RE: Subdivision & Site Plan Approval
Bedford EMP Ownership, LLC - Robert Morse
50 East Middle Patent Road
North Castle (T)

Our office has revised our plans pursuant to the July 6, 2021, Staff Report prepared by the Town Planner and the July 9, 2021, memorandum prepared by Kellard Sessions, Consulting Town Engineer. We offer the following responses for the Board's consideration:

SITE PLAN - LOT 1		DATE:	9-13-2021
MORSE SUBDIVISION 50 EAST MIDDLE PATENT ROAD TOWN OF NORTH CASTLE, WESTCHESTER COUNTY		SCALE:	1" = 30'
BIBBO ASSOCIATES, LLP 295 ROUTE 100 SUITE 203 SOMERS, NEW YORK 10589 TEL. 914 277 5805		FILE:	1-E
		DSGN/CHK:	MG
		DRN. BY:	RH
		SHT NO.:	1 OF 4
		DWG NO.:	SP-1

DRAWING TITLE:
**LOT 1- PROPOSED PRINCIPAL
 RESIDENCE EXTERIOR
 ELEVATIONS 1**

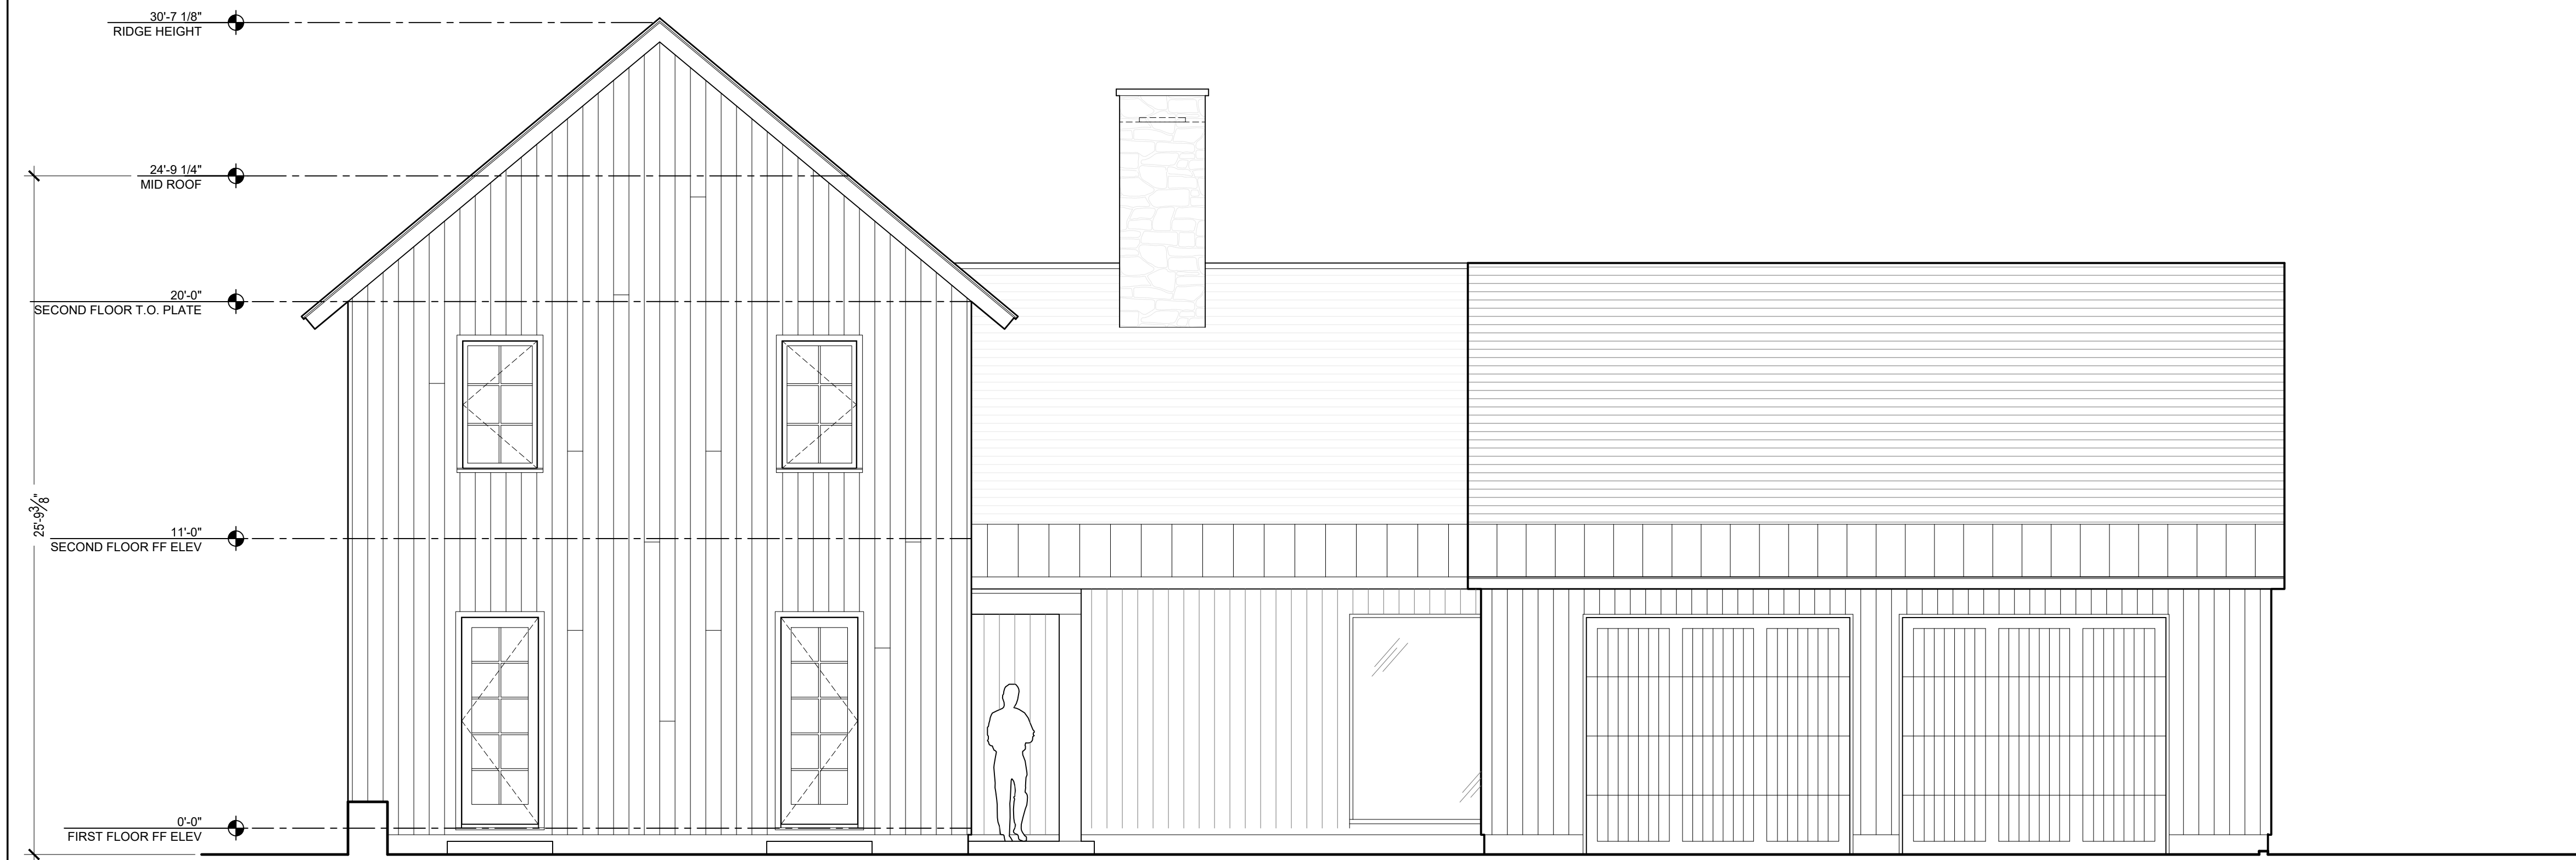
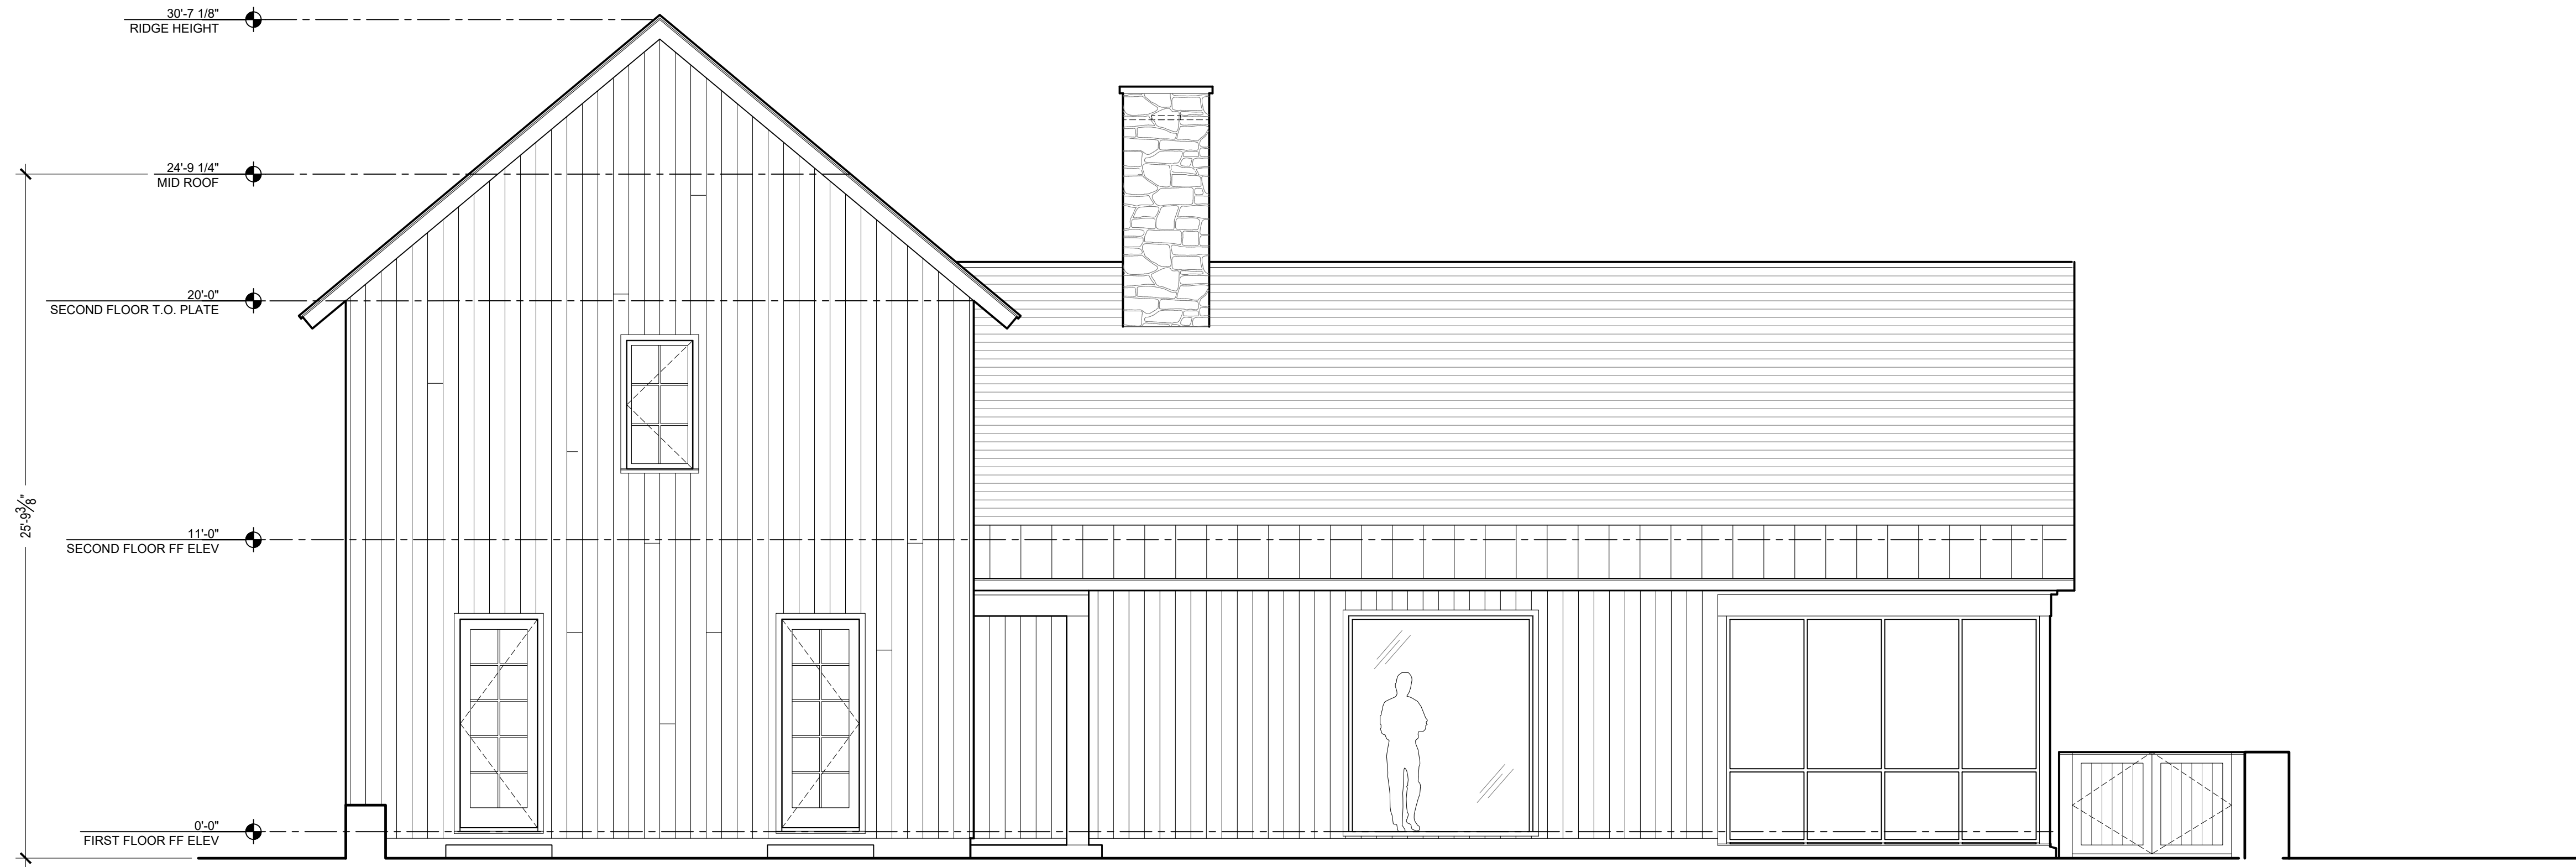
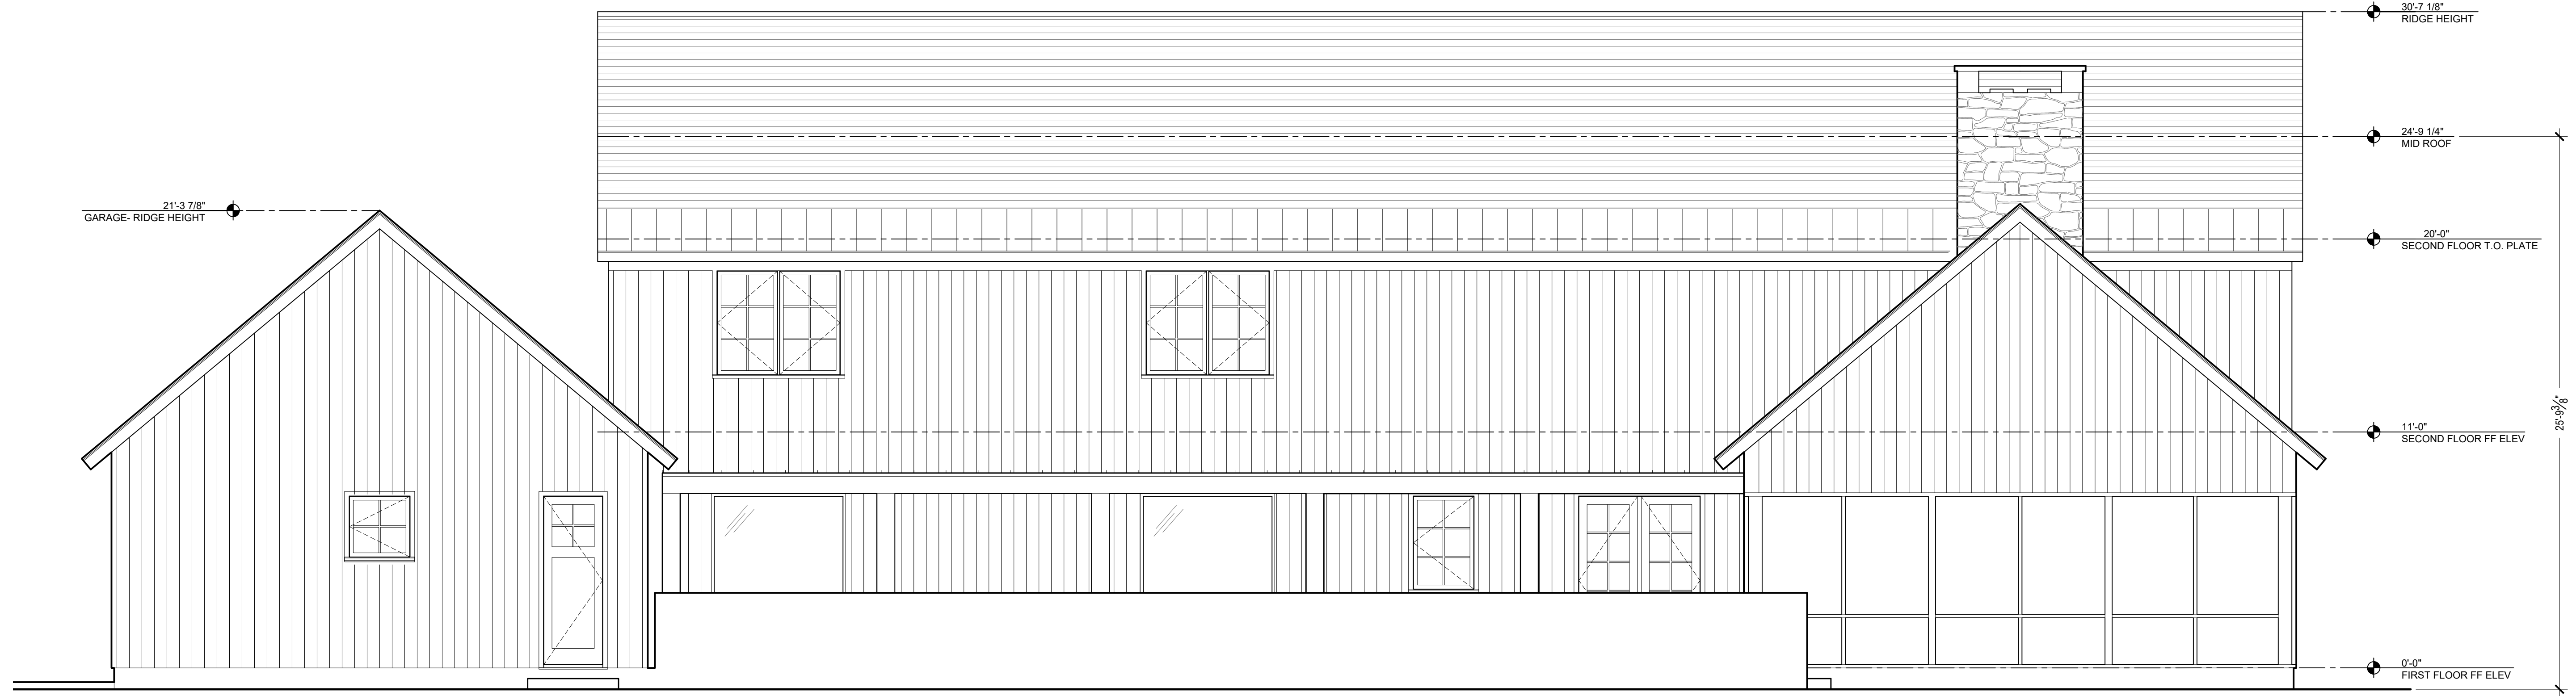
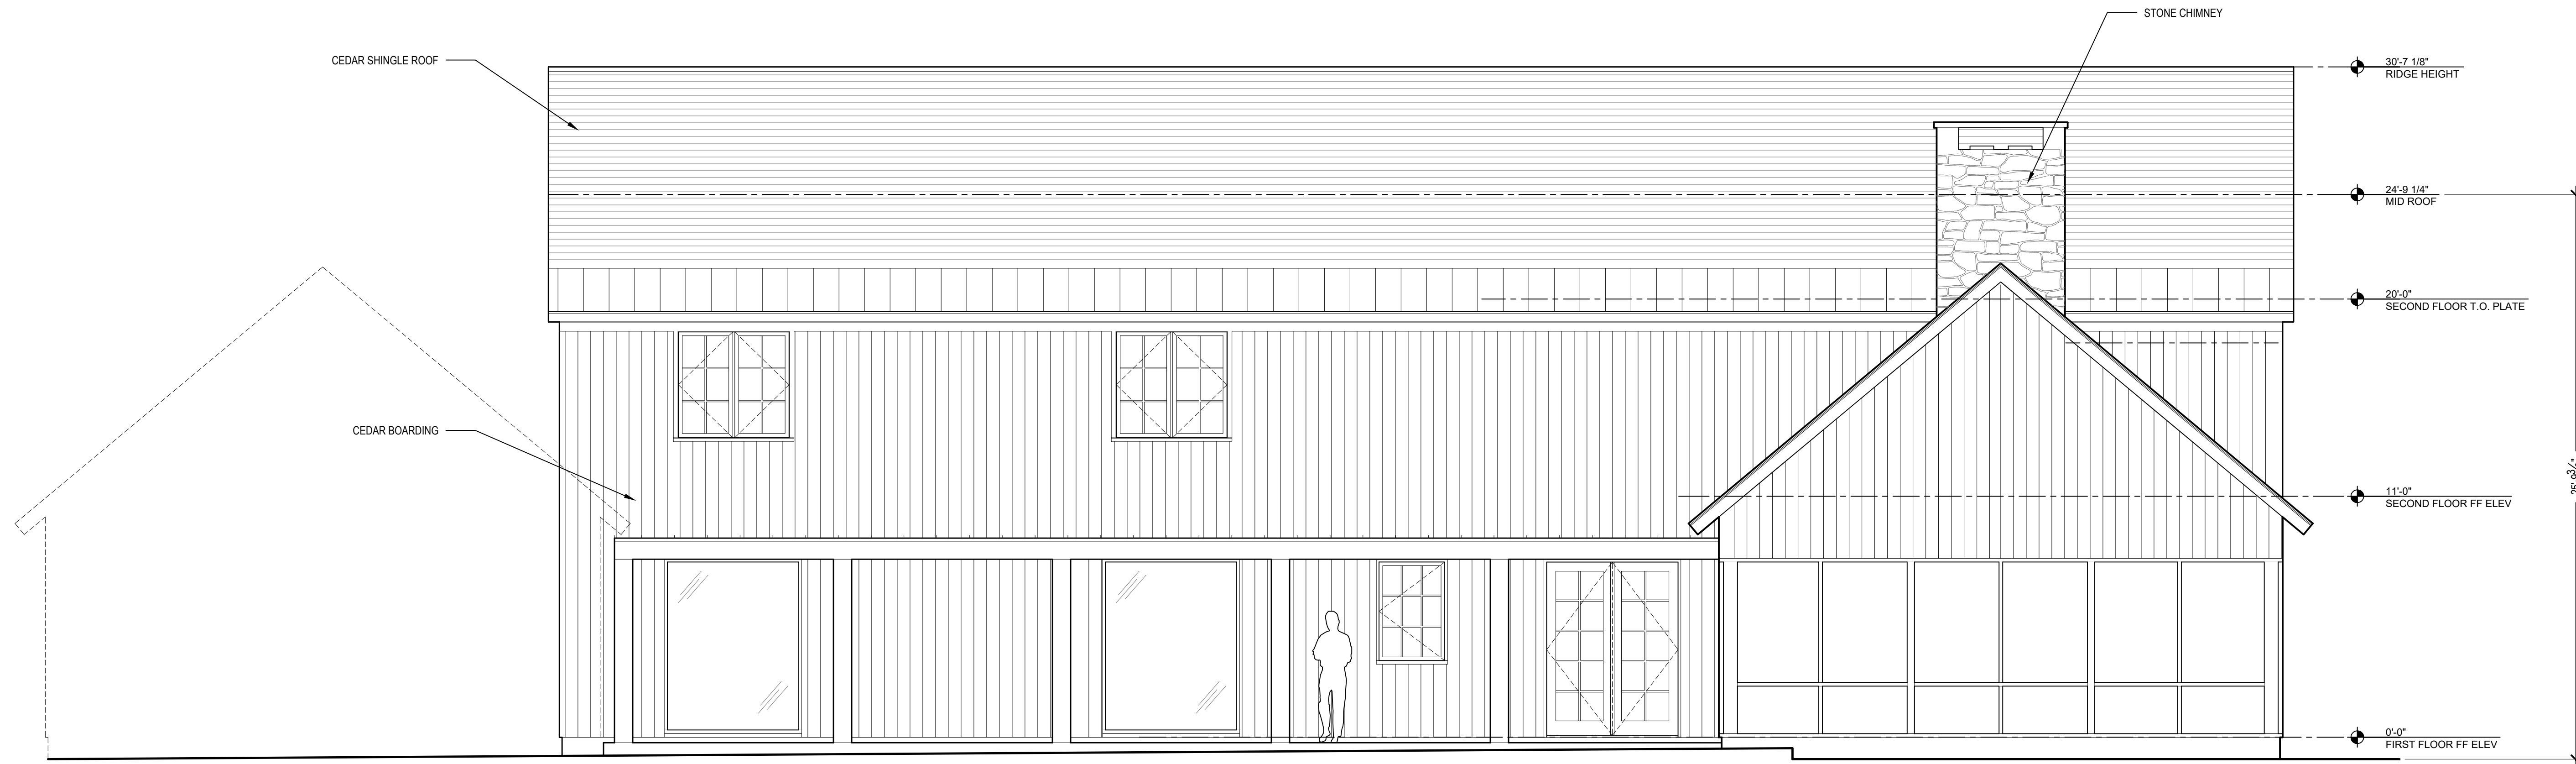
9. Comment noted, the applicant will seek approval from the Zoning Board of Appeals prior to obtaining building permits.
10. Proposed elevations prepared by the project architect are enclosed, and have been revised to depict building heights as requested.
